**SUBPART 3
MINIMAL IMPACT NEW MINING OPERATIONS
PERMIT APPLICATION**

RE: Mining and Minerals Division (MMD) Review of Application for the Billali Minimal Impact Mining Operation, Permit No. GR058MN

Re: Permit No. GR058MN – Billali Patented Lode Claim

BILLALI LODE MINING CLAIM
Mineral Survey Number 1021

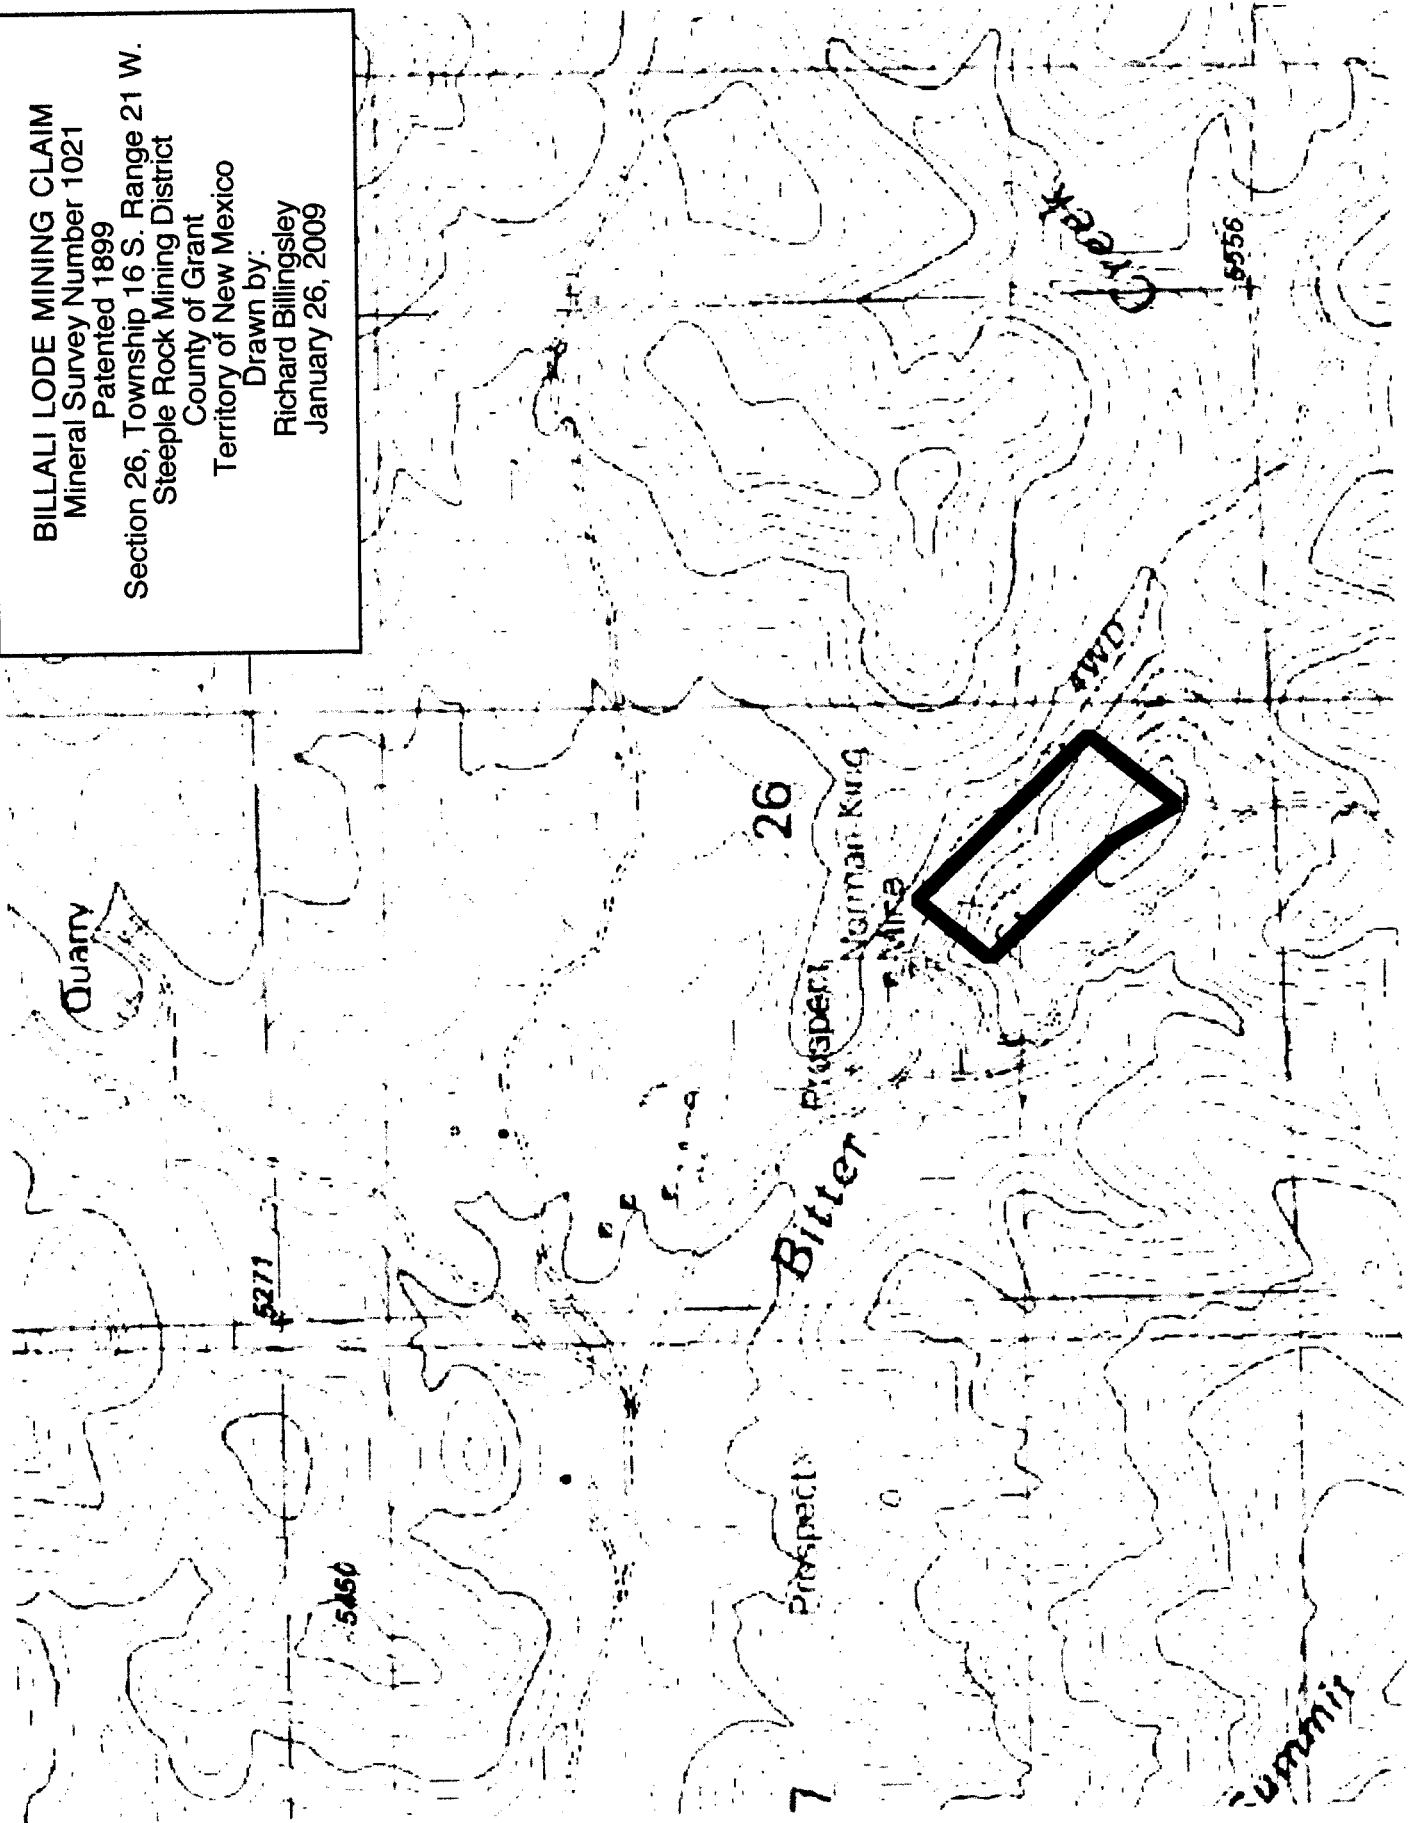
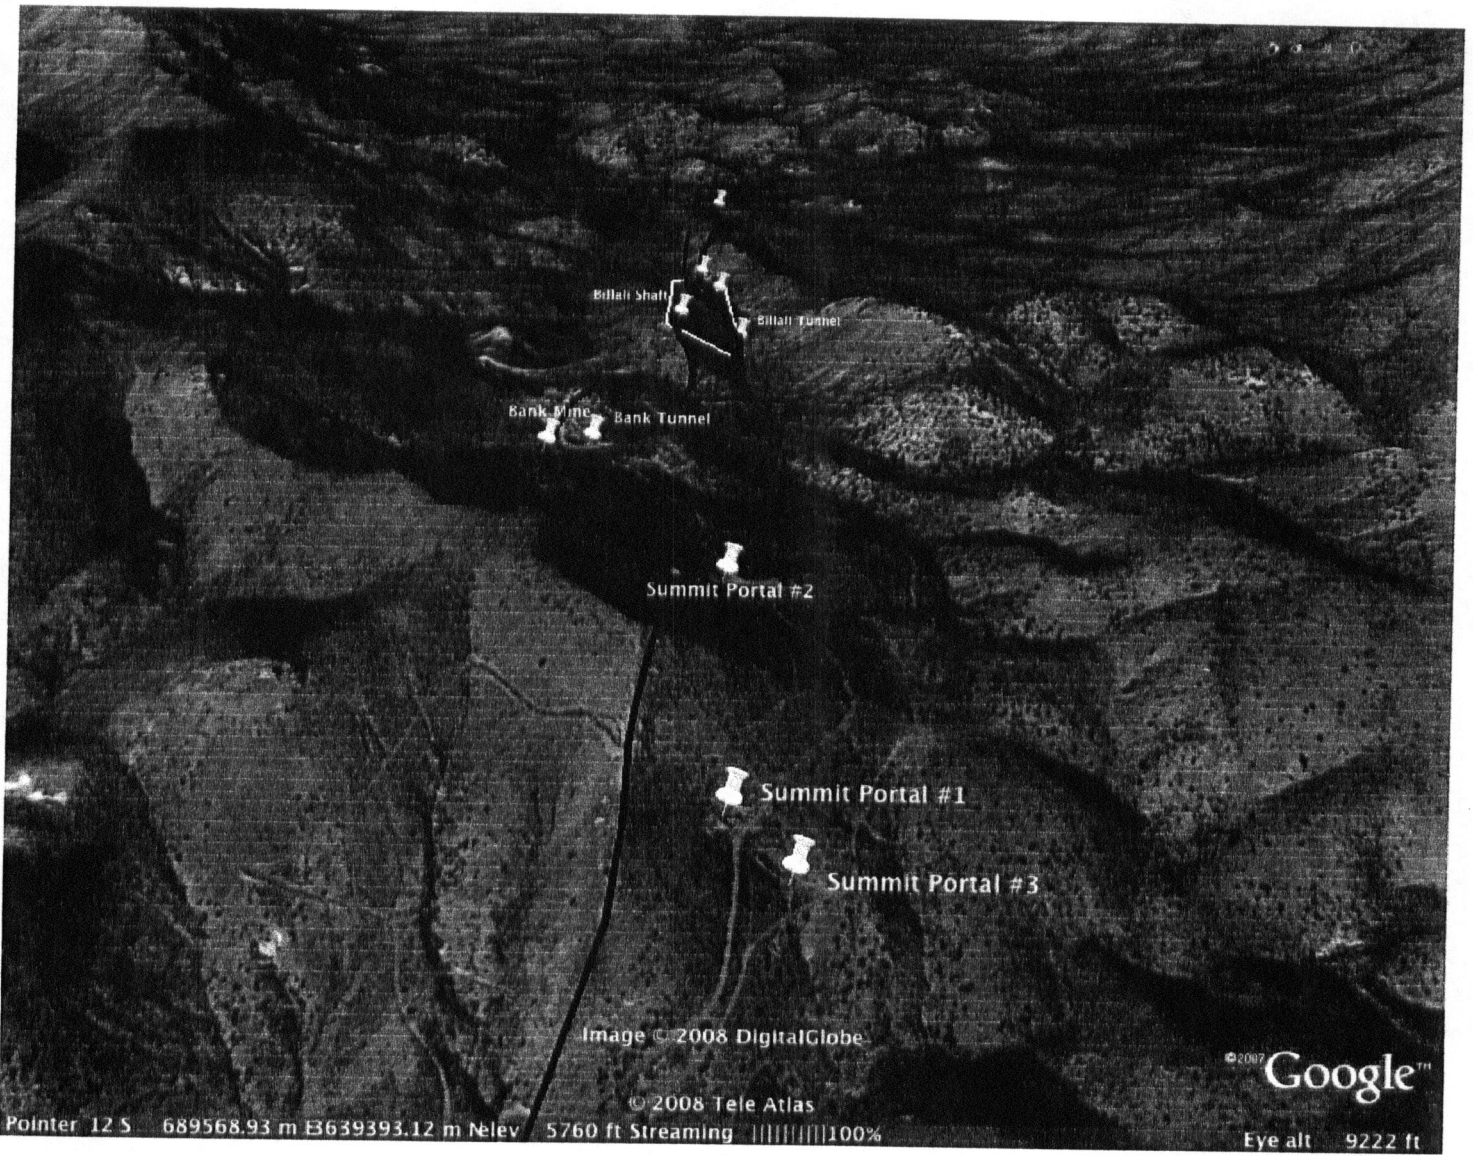
- Page 8 – No. 6 Ground Water Information (§304.D.5)
 - A. Provide an estimate of depth to ground water and the total dissolved solids concentration.

Please provide some data or technical evidence that would substantiate your claim that ground water is at least 100' below ground level. It may be necessary to obtain information about depth to ground water from an engineer or from information supplied by owner(s) of other wells in the surrounding area.

A water sample was taken from the Norman King shaft, on the Norman King claim, which is located 275 feet due west from corner no. 4 (the most northern point of the Billali Patented Lode Claim (see map, Annex B)) of the Billali Patented Lode Claim.

In order to get a sample of water from down the Norman King Shaft, for ground water testing, I tied a glass bottle to the end of a nylon cord and slowly dropped the heavy bottle down the shaft until it reached water level in the shaft, at which time the bottle filled itself with water. A knot was tied in the nylon line from which the distance to the top of the water was measured. This distance was 121 feet. Therefore, since this measurement was made at the distance of 275 feet from

the Billali Patented Lode Claim. It is assumed that that distance is the depth from the surface to the water table on the Billali Patented Lode Claim, which is 121 feet away from where this distance was measured to the water table.
